MEMORANDUM

Re: 1410 South Huron St., Special Land Use/Preliminary Site Plan for True Credit Union

Preliminary Site Plan and Special Use Review For Ypsilanti Township, Michigan

Applicant:	True Community Credit Union (Represented by Heather Colonius)
Project Name:	True Community Credit Union Development and Drive-Through
Plan Date:	April 13, 2026
Latest Revision:	August 25, 2026
Location:	1410 S. Huron St. (On west side of S. Huron Street, just north of Culver's site) Note: The address of this site is 1410 S. Huron St. (per MapWashtenaw)
Zoning:	FB, Form Based District – Town Center; Site Type D
Action Requested:	Preliminary Site Plan and Special Use Approval

1 EAST ELEVATION
A-201 1/4" = 1'-0"

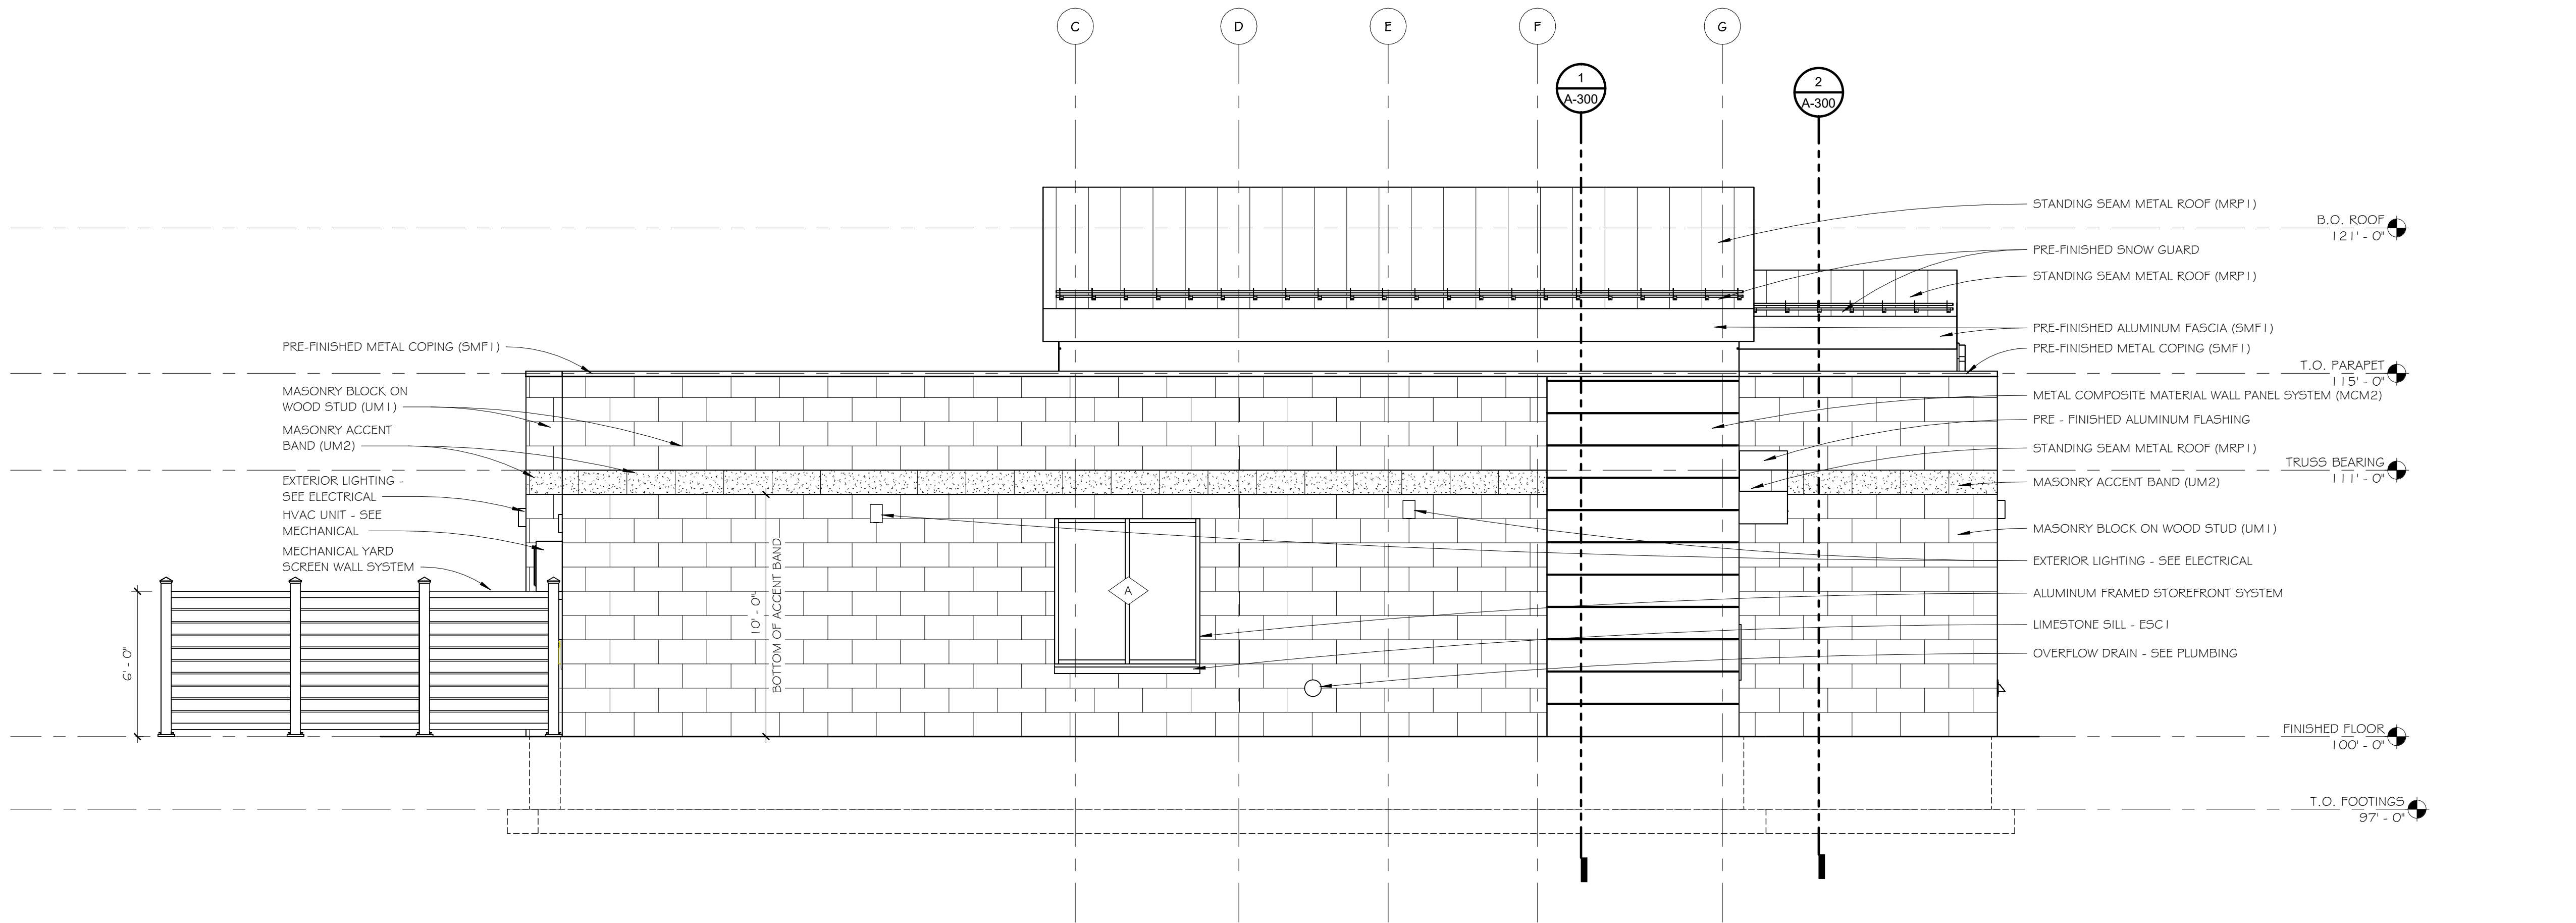
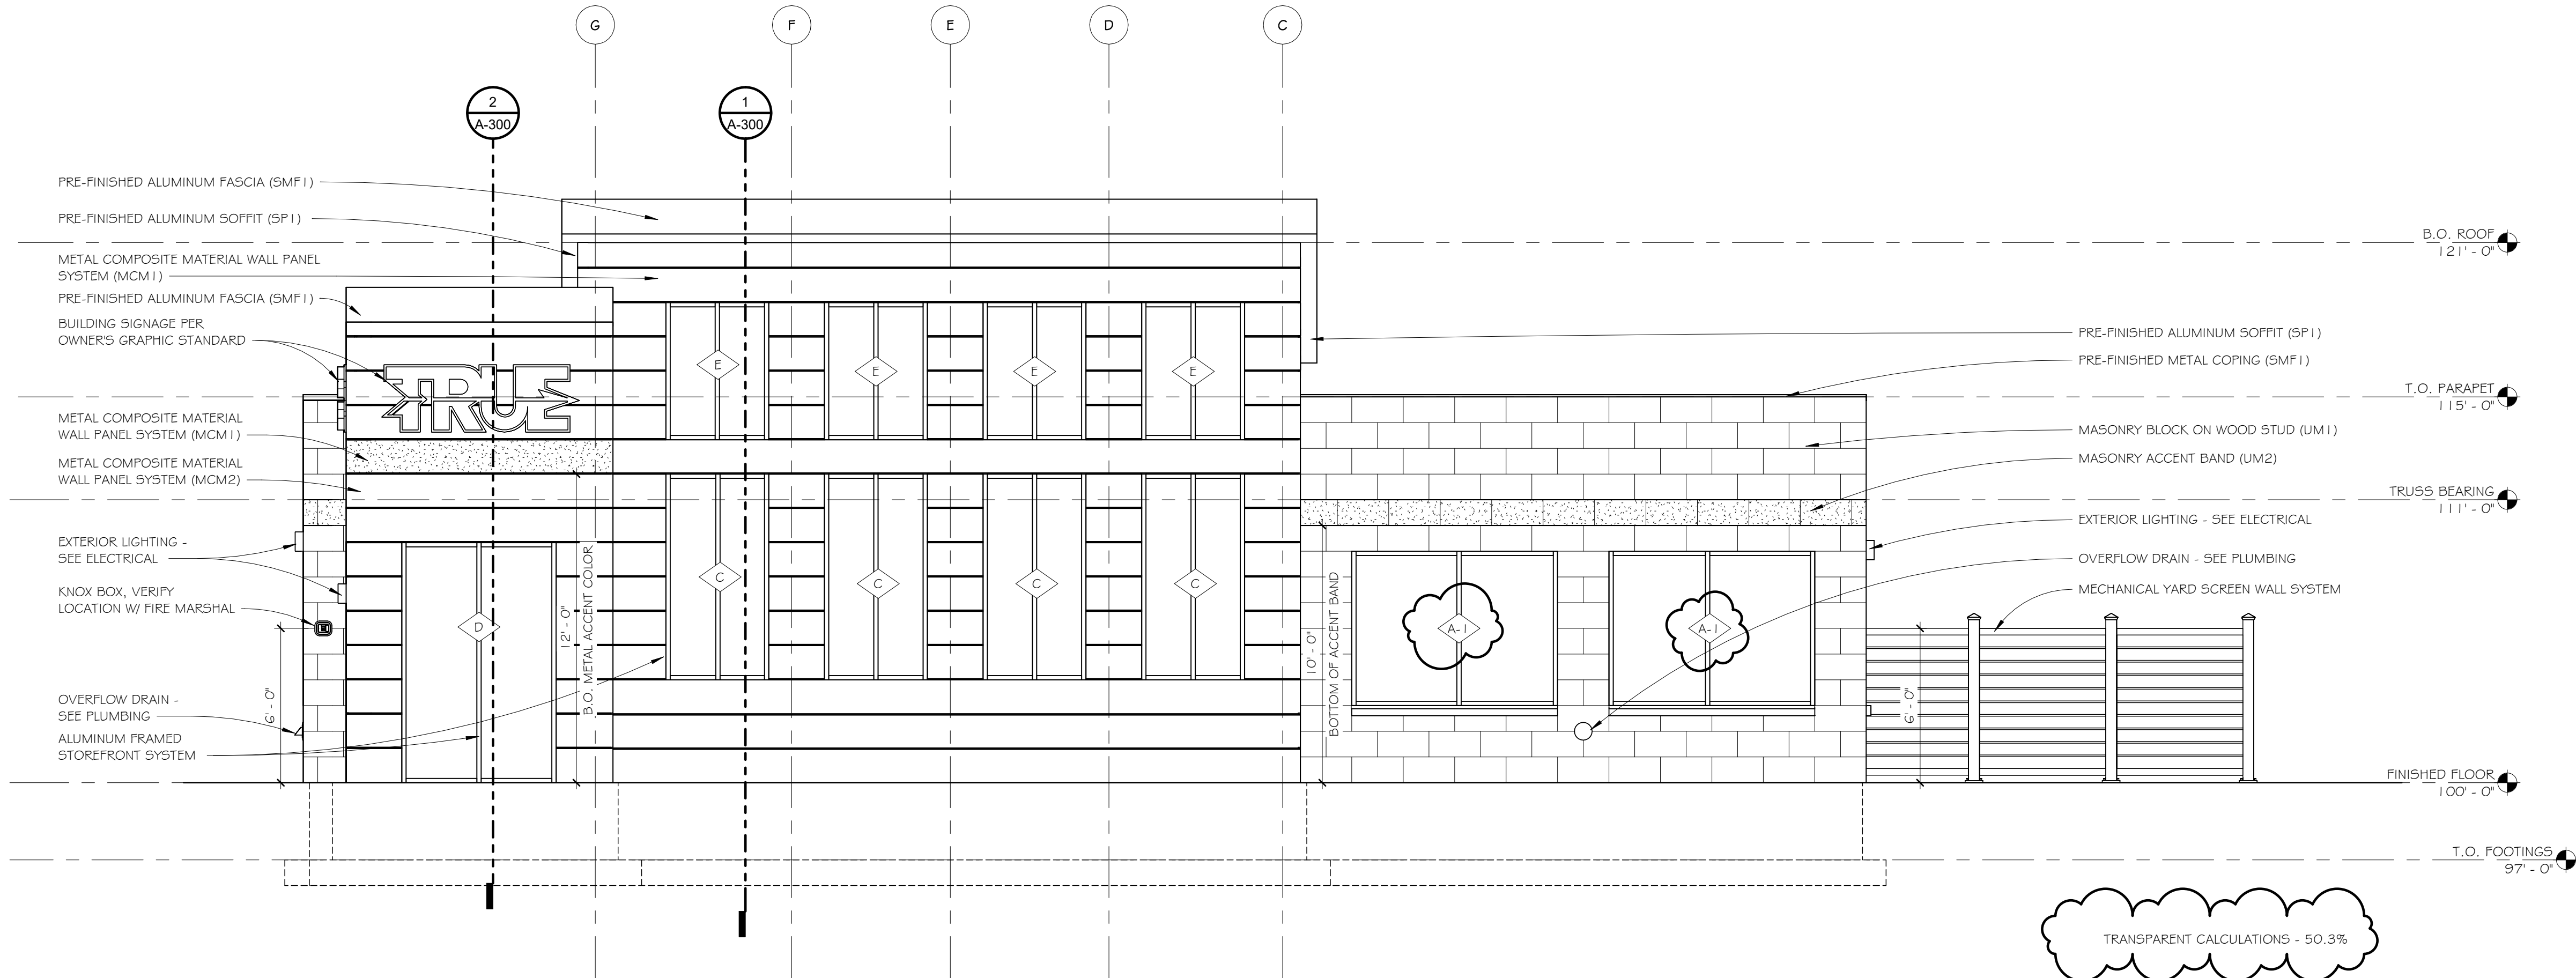
First floors of buildings facing a ROW are required to provide 50% transparency between 2 and 8-feet above grade, and facades facing a parking lot are required to have 30% transparency between 2 and 8-feet above the first-floor elevation. The purpose of this requirement is that windows and doors are arranged so that active uses within the building are visible from or accessible to the street, and parking areas are visible by occupants inside the building. Transparency calculations are shown on the plans for the East (front) and South (parking) architectural elevations.

On the front façade, the wall design includes changes in plane (the façade steps back from the front entry), a belt course of split-faced CMU, and variation in color. In our opinion, the design meets the standards for the “wall design” transparency alternative. The Planning Commission will need to evaluate the front façade against these standards.

Items to be Addressed: 1) Planning Commission to evaluate East (front) façade and determine if the design meets the standards for transparency alternatives (as this façade is slightly under the required 50% transparency requirement).
